**CULTURAL RESOURCES OFFICE  
PRESERVATION BOARD  
REGULAR MEETING  
MONDAY JUNE 27, 2011  
1015 LOCUST ST. #1200  
4:00 P.M.**

**DATE:** June 27, 2011  
**FROM:** Jan Cameron, Preservation Administrator, Cultural Resources Office  
**SUBJECT:** Preliminary review to construct a two-story single-family house  
**ADDRESS:** 1710 Carroll Street  
**JURISDICTION:** Lafayette Square Historic District — Ward 6

**DATE:** June 27, 2011  
**FROM:** Jan Cameron, Preservation Administrator  
**SUBJECT:** Preliminary Review: to construct three attached single-family houses with detached garages  
**ADDRESS:** 800, 802 and 804 Ann Avenue  
**JURISDICTION:** Soulard Historic District — Ward 7

**DATE:** June 27, 2011  
**FROM:** Andrea Gagen, Cultural Resources Office  
**SUBJECT:** Appeal of a staff denial to replace windows on a Public Facade  
**ADDRESS:** 1828 Hickory Street  
**JURISDICTION:** Lafayette Square Local Historic District — Ward 6

**SIDE ELEVATIONS**

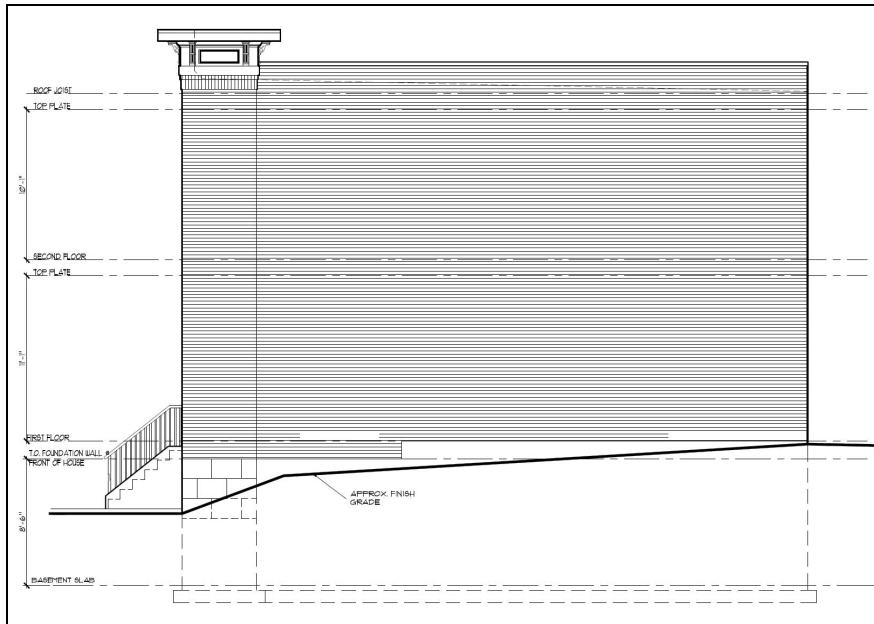
**Comment:** The east side elevation is an Intermediate Façade. The rear elevation facing south is considered a Private Façade.

**Comment:** There are two Public Facades, the primary elevation facing Carroll on the north and the side elevation at S. 18<sup>th</sup> Street on the west.

REAR ELEVATION

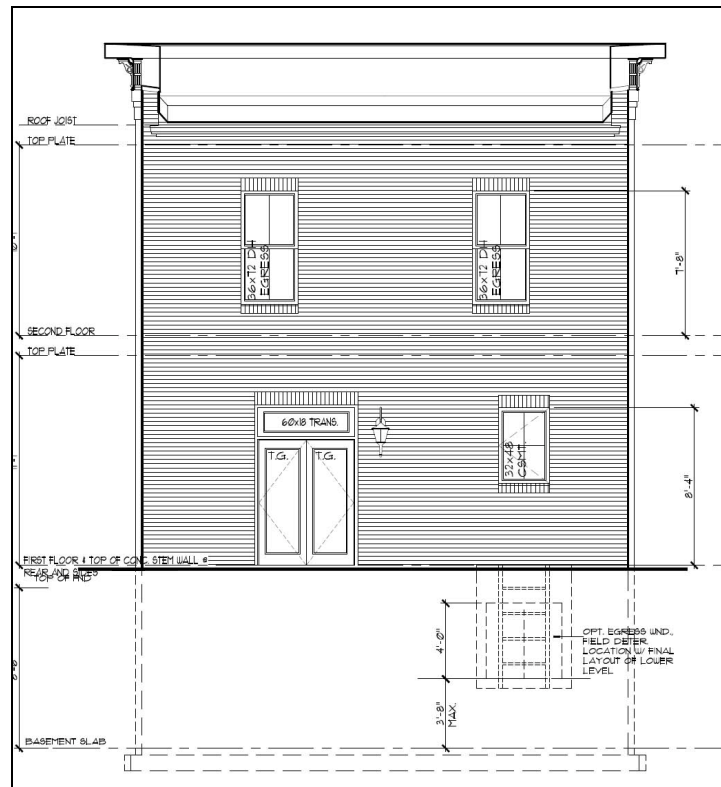
**Partly complies.** While the new building has the same number of stories as other residential properties in the immediate area, the proposed floor-to-

ceiling heights are greater: 11 feet at the first story and 10 at the second, adding approximately 2 feet to the height of the front elevation.

**Appears to comply.** The building approximately 2 feet taller than other two-story, flat-roofed buildings in the vicinity.

GARAGE ELEVATIONS

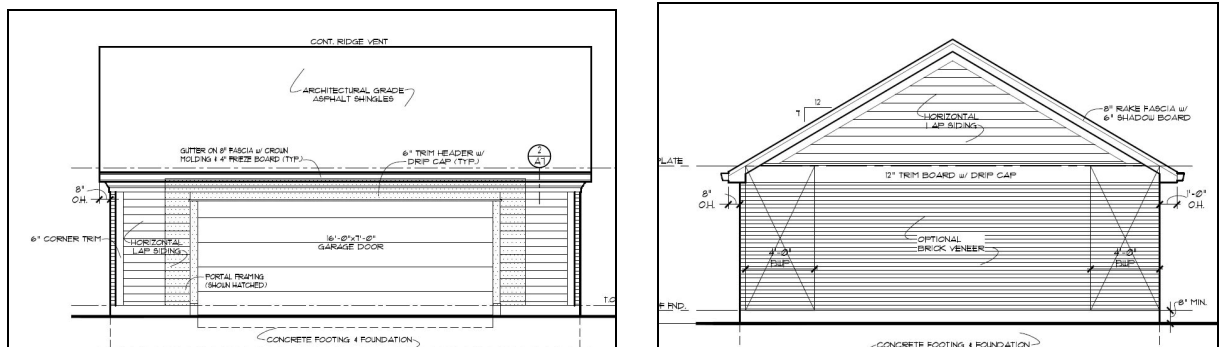
**Partly complies.** The block currently has an L-shaped alley that provides access to only half of the development site. The developer

plans to provide access for the remainder of the site with a shared drive.

**Complies.** The garage will have a brick façade facing the house and a sided façade at the alley. Brick veneer on the secondary elevations will be offered as a buyer option.

FRONT ELEVATIONS WITH ADJACENT BUILDINGS AT 710 AND 808 ANN

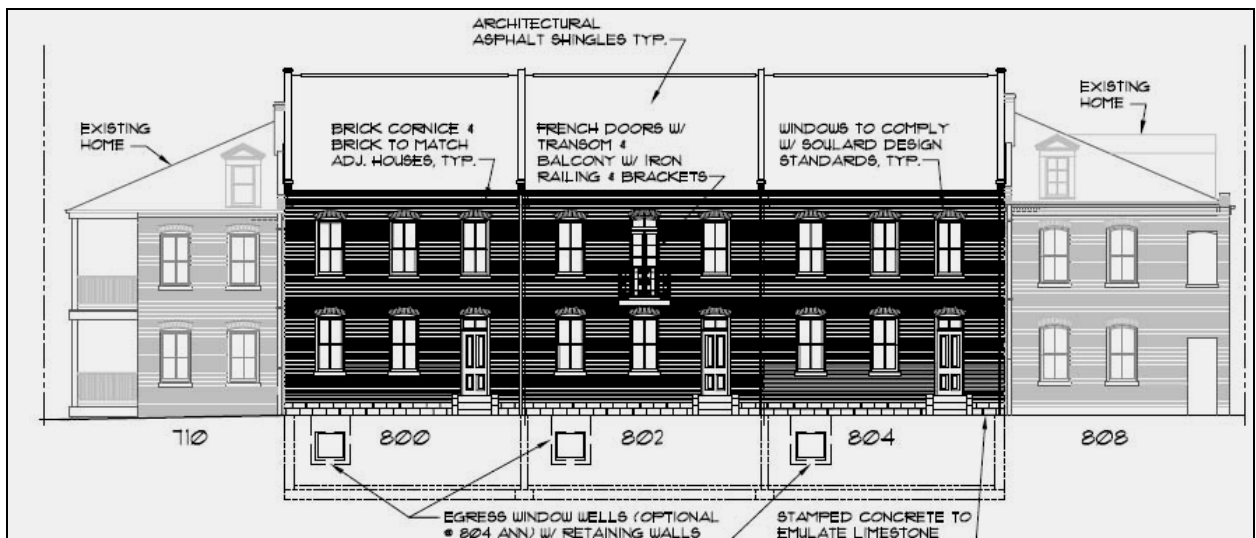
**Partly complies.** The three buildings will appear to be two and one-half stories, as are the adjacent flounder houses that bookend the site. However, the buildings have a basement level, which the end units do not — and floor lines are slightly higher. Differing floor-to-ceiling heights are characteristic of many blocks in Soulard, and of this block in particular.

CENTER BUILDING FRONT ELEVATION WITH BALCONY AND FRENCH DOORS

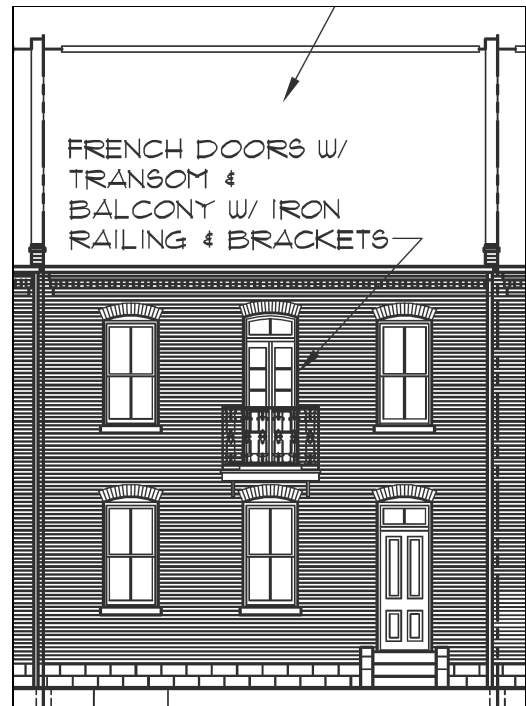
Two small details remain: the Model Examples submitted have all had their second story balcony openings altered. Originally, these balconies were accessed through a Jefferson door. The developer is requesting that he be allowed to install a French door in this location. The staff does not feel that this is a major deviation from the standards.

**SOUTH (REAR) ELEVATION WITH SOLAR PANELS ON CENTER BUILDING AND REAR ONE-STORY PORCHES  
CENTER UNIT WILL HAVE A RECESSED SCREENED PORCH AT THE FIRST STORY**

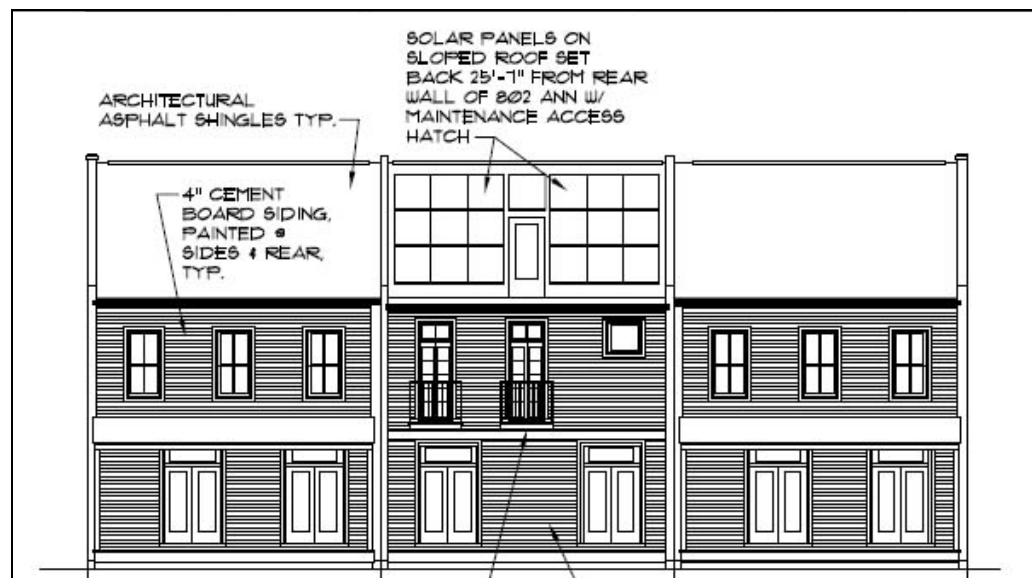
The second issue is the installation of solar panels on the rear roof slope of the middle building. The standards do not address solar panels or similar appurtenances. The panels will not be visible from Ann Avenue, although they may be somewhat visible from S. 7<sup>th</sup> Street on the east.

GARAGE ELEVATION AT ALLEY

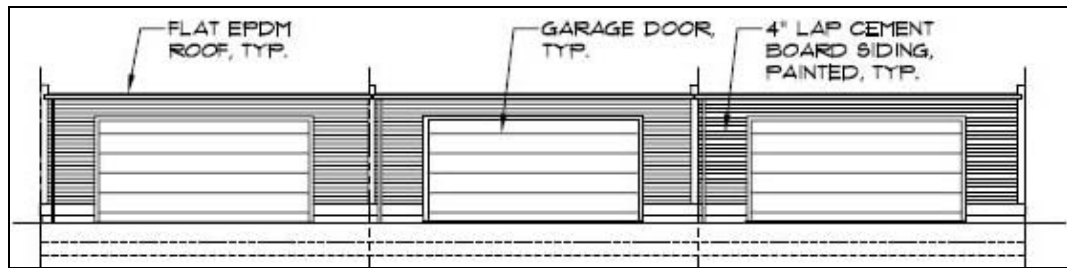
**Complies.** The proposed detached garages adhere to these requirements.
